Application : 10/047928

EXAMINER'S AMENDMENT

IN THE DRAWINGS:

FIG. 1
PRIOR ART

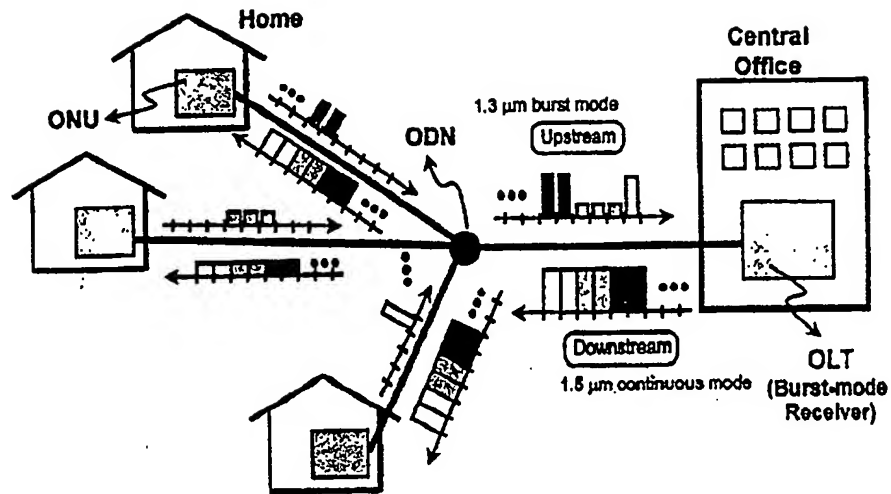
- In figure 1, a label "PRIOR ART" is added to the figure.
- In figure 2, a label "PRIOR ART" is added to the figure.
- In figure 3, a label "PRIOR ART" is added to the figure.
- In figure 4A, a label "PRIOR ART" is added to the figure.

CORRECTED DRAWINGS
ATTACHED
